Significant Further Information Response

Observation to An Coimisiún Pleanála

1. **Reserve Gas-Fired Generator (OCGT)** — ABP-320095-24 / (s.37E SID)
2. **Battery Energy Storage System (BESS)** — ABP-320916-24 (s.37 appeal, GCC ref 24/60845)
3. **400 kV Gas-Insulated Switchgear Substation (GIS)** — A07.320094 (s.182A SID)

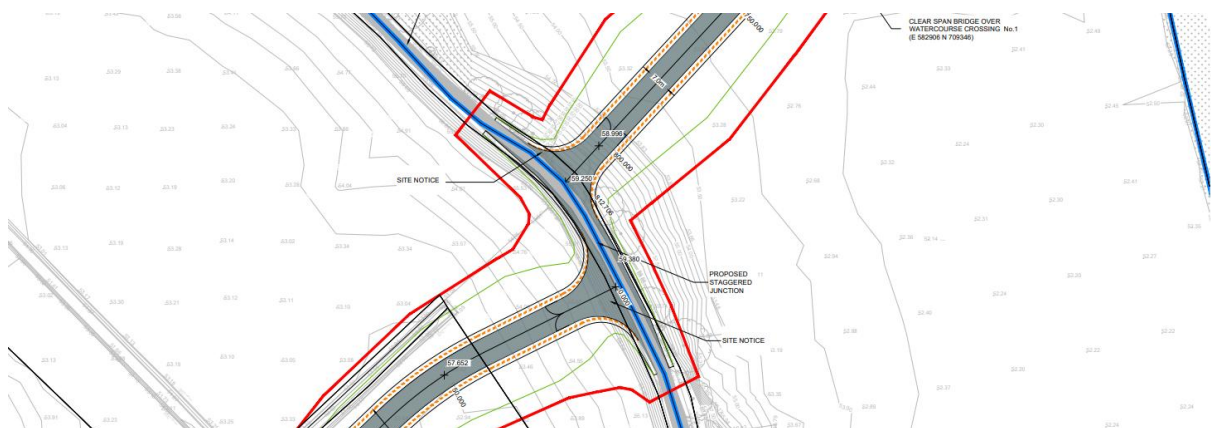
The applicant's proposed staggered junction is situated along an esker ridge, as evidenced by the contours in the mapping. This esker ridge is a notable standout feature of the local area, and the GCDP also recognises *"the unique importance of Galway's esker landscape deriving from its geological, zoological, botanical, scientific and landscape value"*¹⁵⁷.

It goes without saying that the proposed staggered junction would do even more damage to this esker ridge than the applicant's original 2024 proposal.

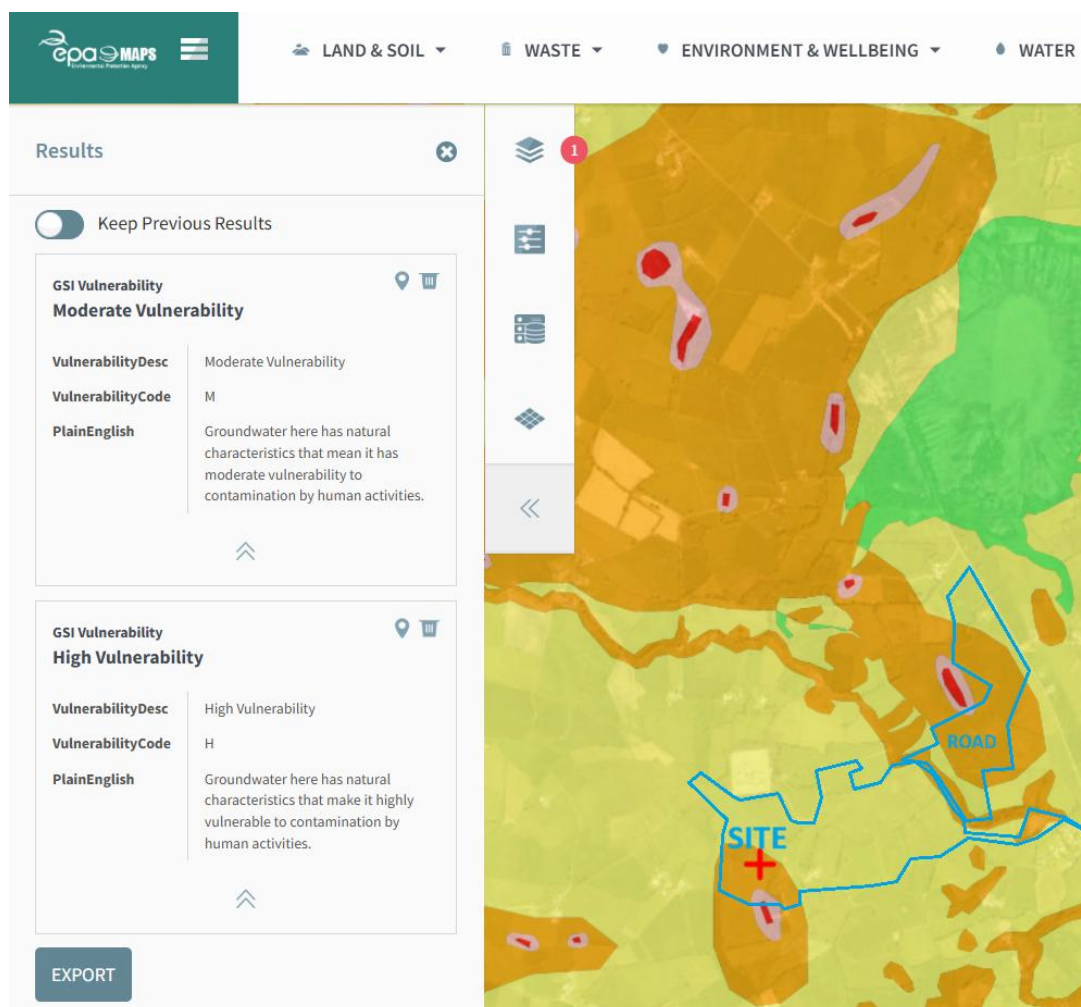
Instead of 7,647 HGVs for fill, we have calculated 33,707 HGVs (i.e. 67,414 movements) – 441% of the EIAR's fill estimation.

Figure 8.1 Catchment Map

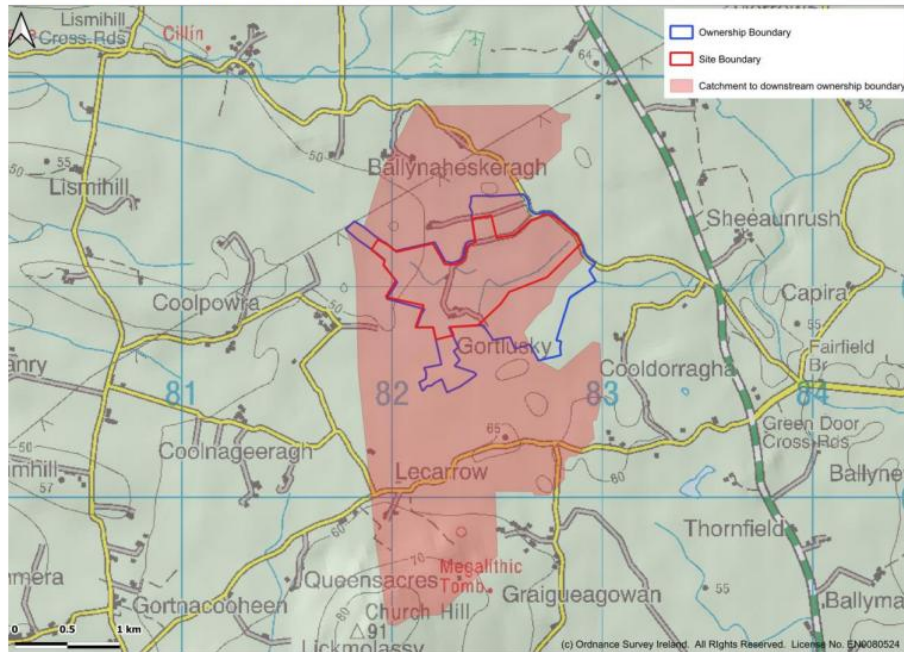
As a result, the site and surrounding lands flood regularly (as the photographs show) in the winter. The photographs reflect the significant concerns of the surrounding landowners, whose local knowledge is that the watercourse carries far more water, and floods more often, than the EIAR presents. Those landowners are also concerned about what the proposed works would do to their own lands capacity to absorb rainfall, and whether the development would worsen the flooding they already experience.

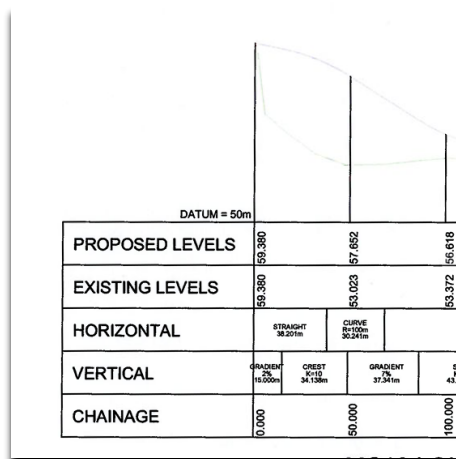
It is noteworthy that the cut & fill requirements of the proposed new access track have not been considered in this calculation. That proposed road has a footprint of approx. 7,763sqm (1,109m Long * 7m Wide). Drawing CPA-HAL-NR-XX-PL-3000 shows cuts of up to 2m being required and areas of fill of up to 6m of fill being required. This is a significant oversight in the cut & fill calculation. The road construction required is complex. Between chainage 700 and chainage 812, the proposed road will rise by 6.59m from existing ground levels. Between chainage 0 and chainage 50, the proposed road level will rise by 6.35m. This proposed road elevation rises to the top of a local esker which brings with it increased environmental considerations.

Proposed Road Long section detailed on Drawing CPA-HAL-NR-XX-PL-3000. Proposed 6.59m increase to existing levels. There is approx. 2,580m³ of fill required in this small area alone. (112m long * 7m wide * 3.3m avg. depth). It is not accounted for in the addendum.

Proposed Road Long section detailed on Drawing CPA-HAL-NR-XX-PL-3000. Proposed 6.35m increase to existing levels. There is approx. 1,110m³ of fill required in this small area alone. (50m long * 7m wide * 3.18m avg. depth). It is not accounted for in the addendum.

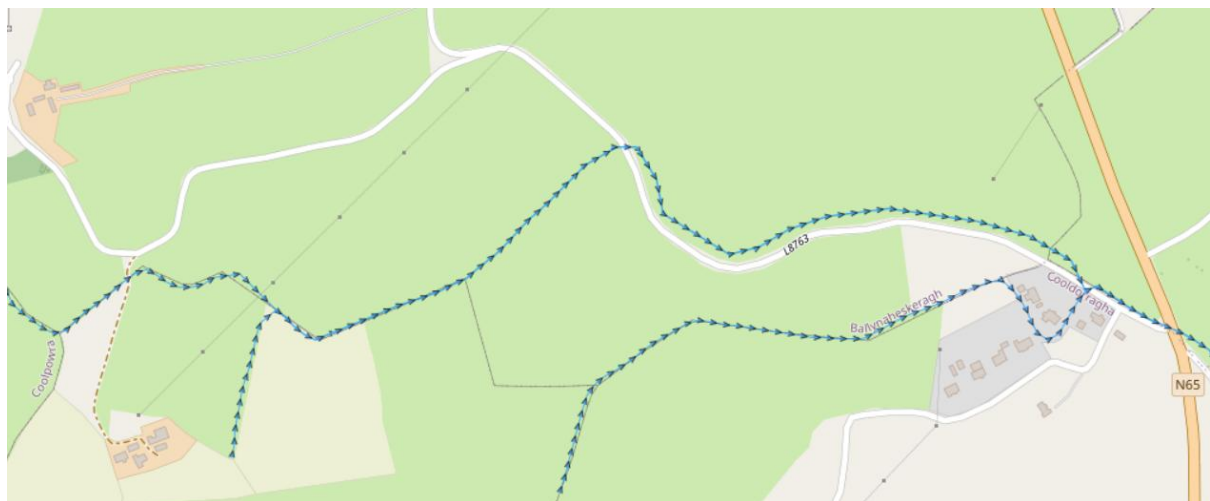
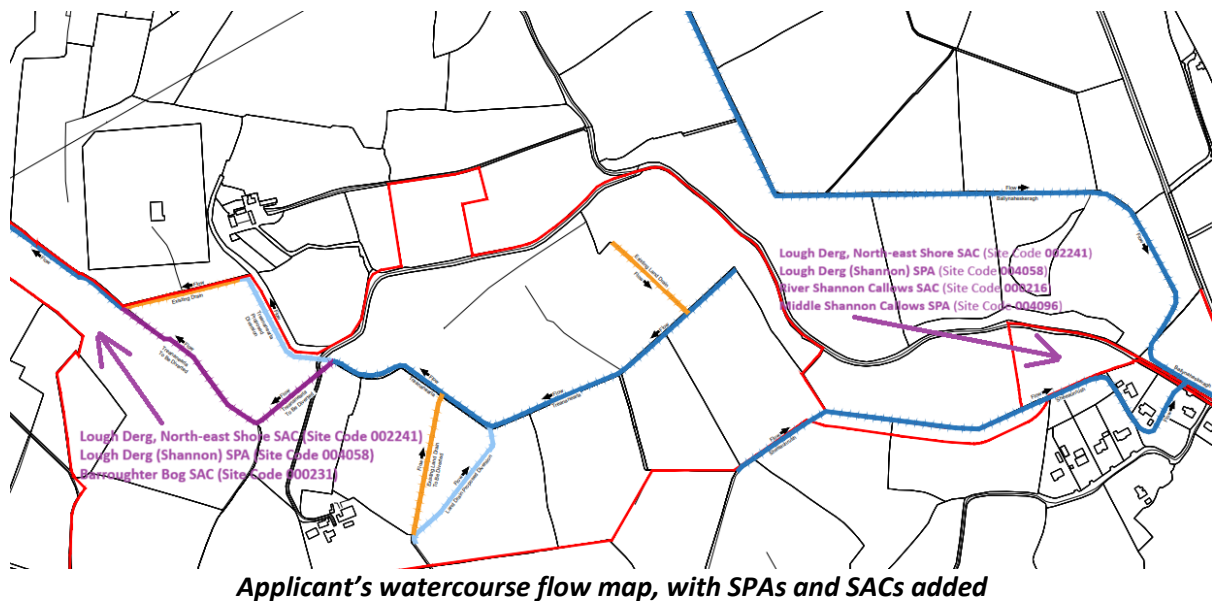
“Submit a suitably scaled drawing clearly identifying and labelling all existing watercourses and drainage ditches running from outside and through the site to include direction of flow. Figures 6.3 and 8.3 of the submitted EIAR and submitted layout drawings are considered insufficient in this regard”¹⁸³

While the developer has submitted a drawing in relation to above (CPA-HAL-MP-XX-DR-PL-10000), it is not sufficient. It is notable that the submitted drawing does not identify and include the details of the newly proposed site access road together with the watercourses. It also appears that multiple watercourses have been overlooked on the drawing. The developer has acknowledged at least two watercourses being affected by the newly proposed access road. Those watercourses are not identified on the drawing. The developer has therefore failed to provide the required information.

Figure 3.1 Site Layout Iteration (example 1)

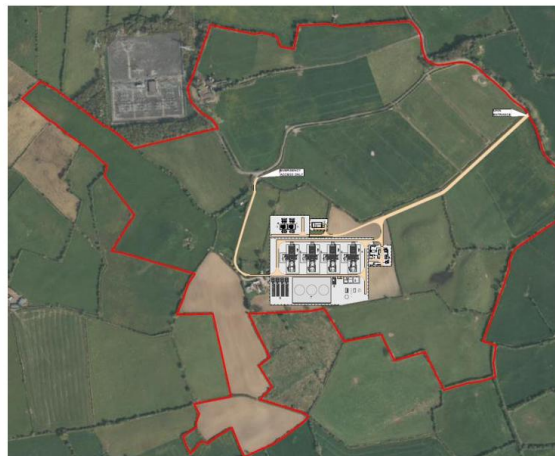
This site layout was rejected internally by the developer for reasons unknown. While some reference is made to the repositioning indoors of specific items of equipment, no explanation is offered for the sudden relocation of the layout which interfered drastically with the Treananearla Stream.

It is critical to bear Figure 3.1 above in mind, as it raises concerns around many of the internal site “justifications” put forward by the developer in its response to the Further Information request. The developer states “Options to reduce the extent of realignment were considered” – Figure 3.1 showed a stream realignment was not actually required. One must ask why this option was ignored.
